ADDENDUM NO. 2

**Spokane Public Schools
Libby Center Classroom Remodel**

ALSC Project No. 2020-033

EXTERIOR FOOTING AND STEMWALL AT GLAZING

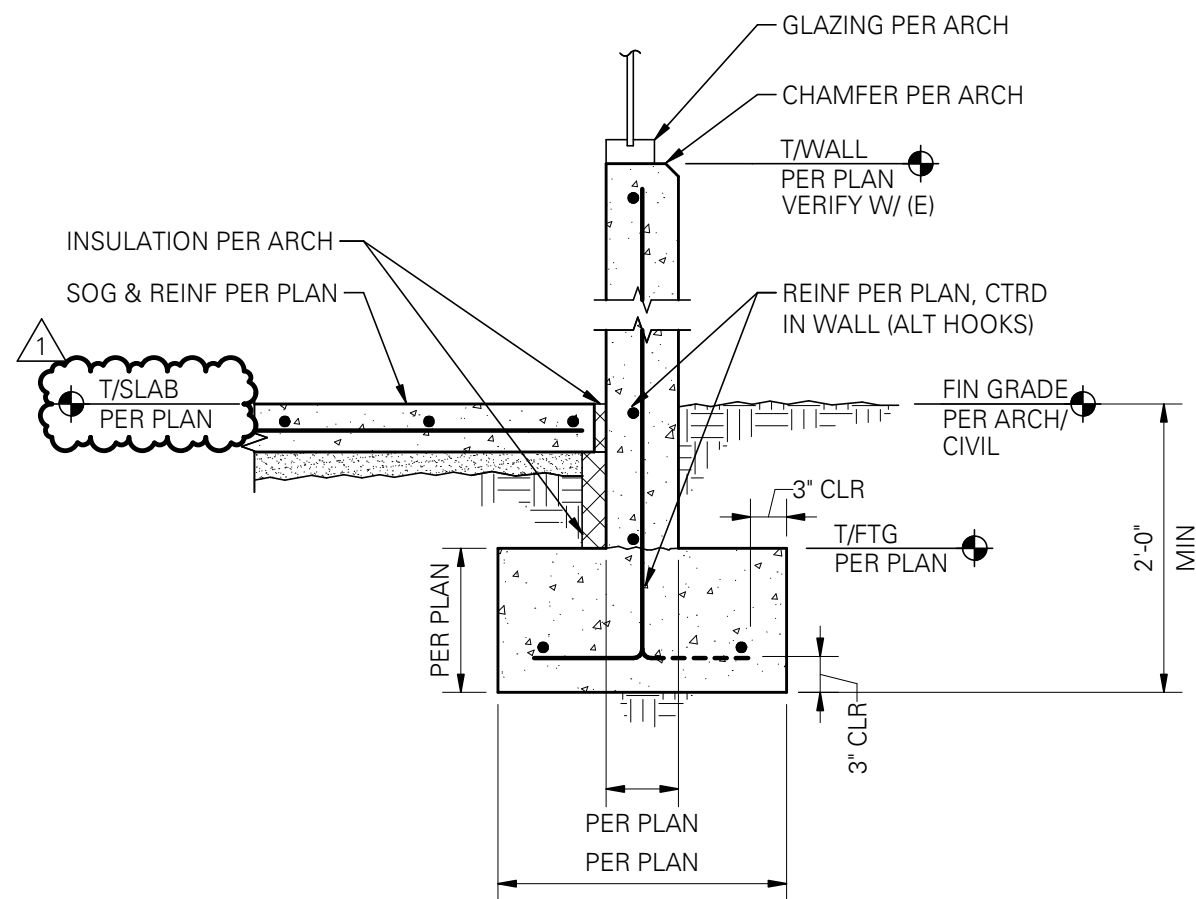
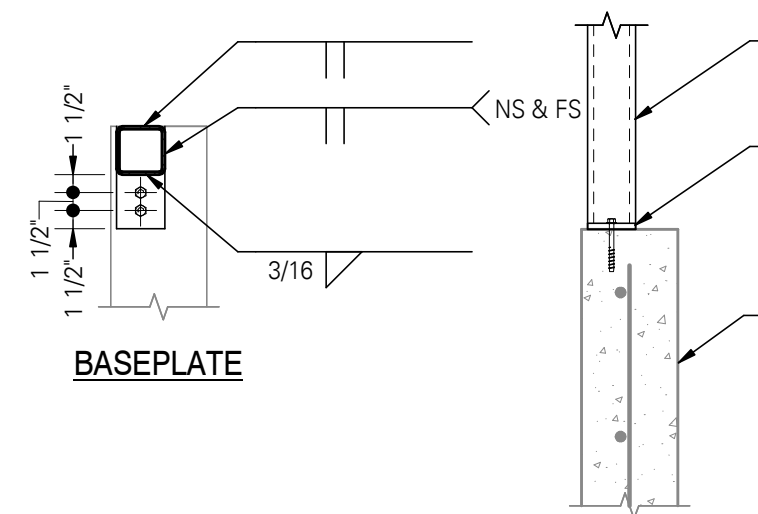
DATE	DRAWN	DWG. NO.	JOB NO.	REF. SHT.
2021-04-20	DJM	SC-03	21041-0011	S-210
DESCRIPTION REVISED 4/S-210

BOTTOM OF FOOTING TO MATCH
BOTTOM OF EXISTING FOOTING.

TRENCH INFILL DETAIL

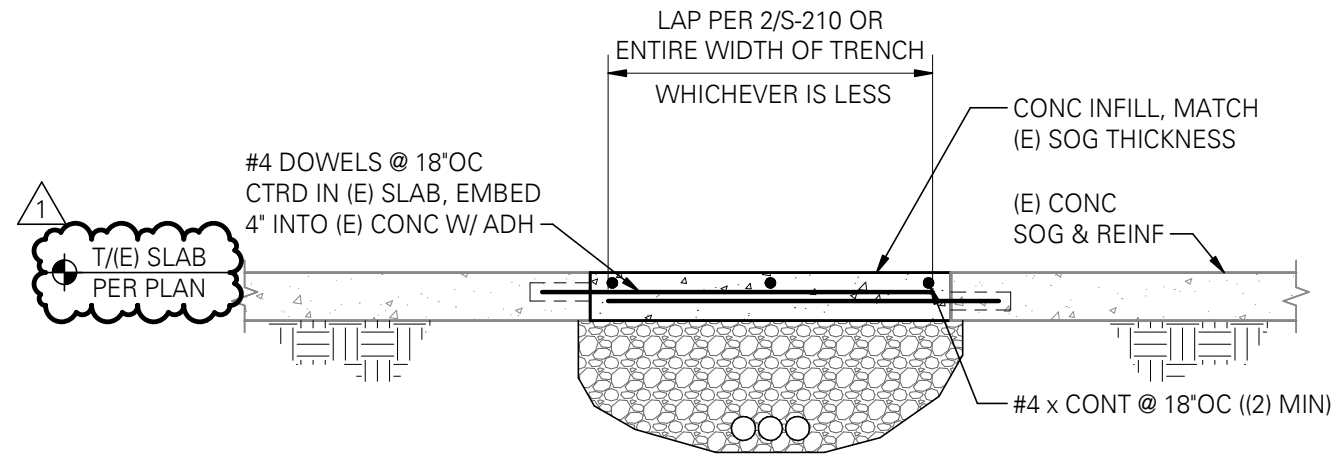
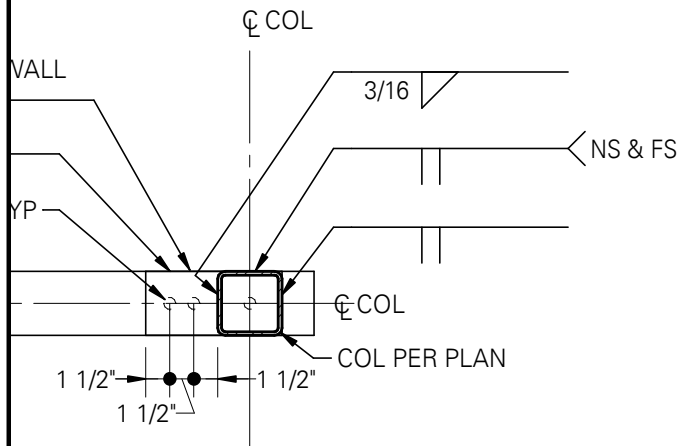
DESCRIPTION
REVISED 6/S-210

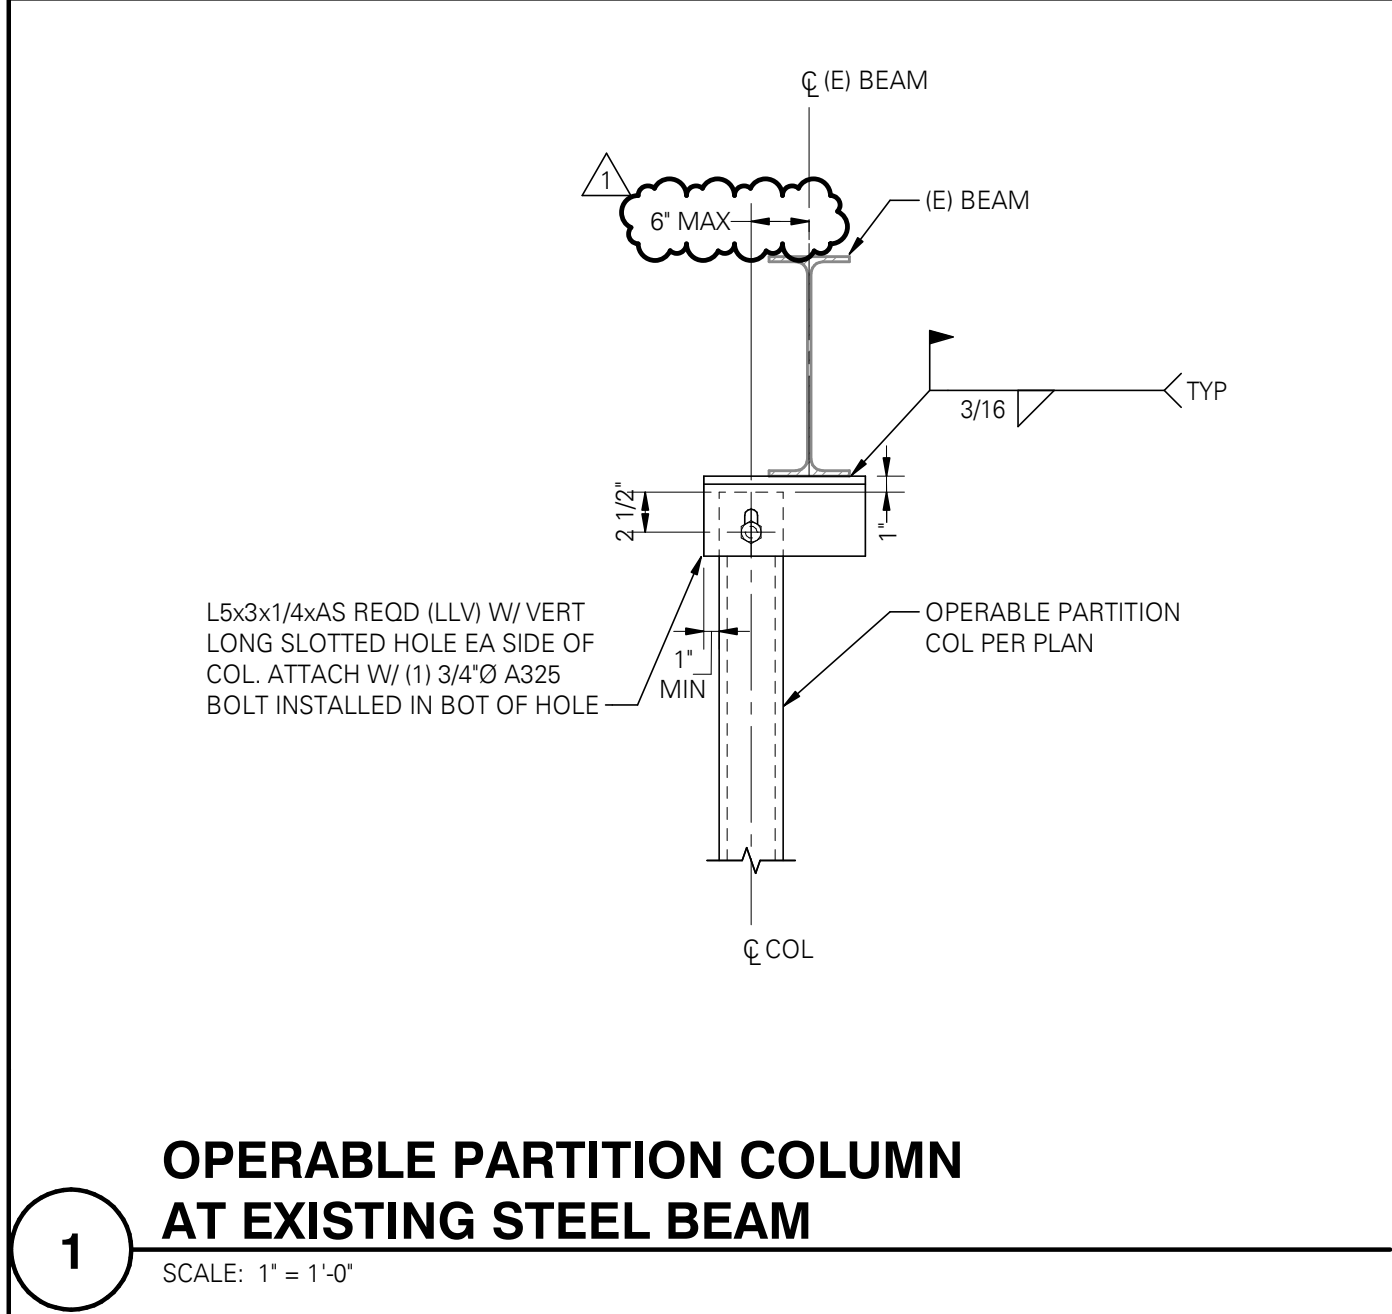
DESCRIPTION
REVISED 9/S-210

OPERABLE PARTITION ATTACHMENT

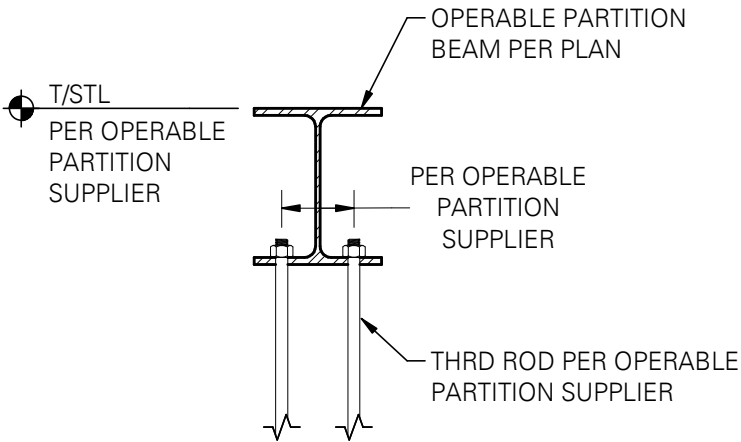
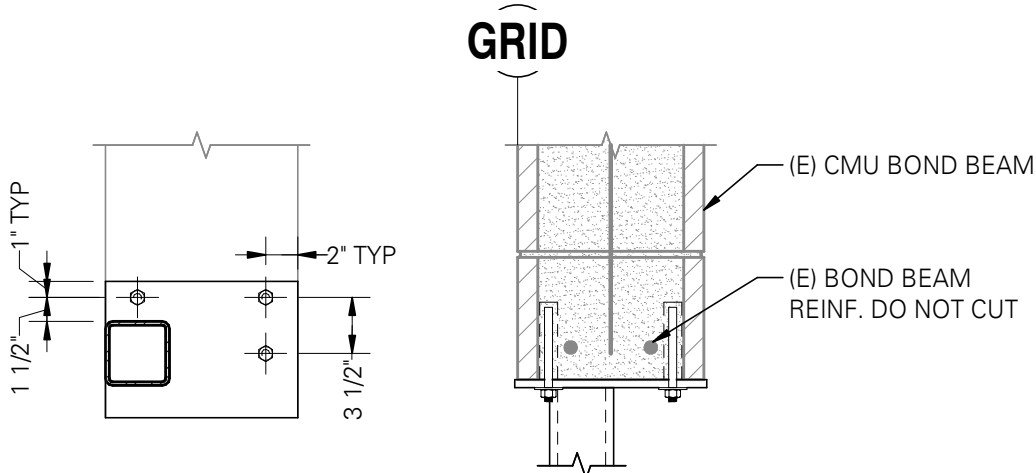
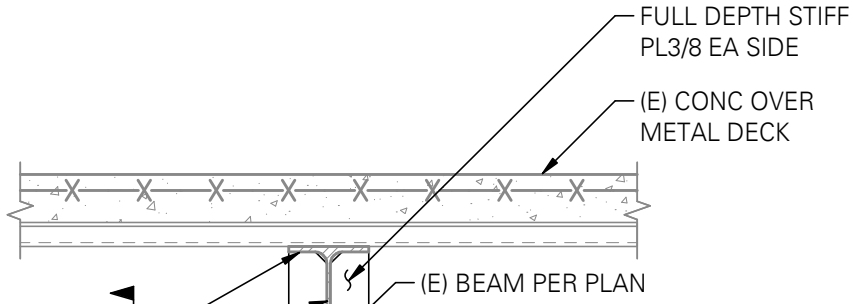
DESCRIPTION
REVISED 1/S-310

MAXIMUM PARTITION HEIGHT 9'-0"
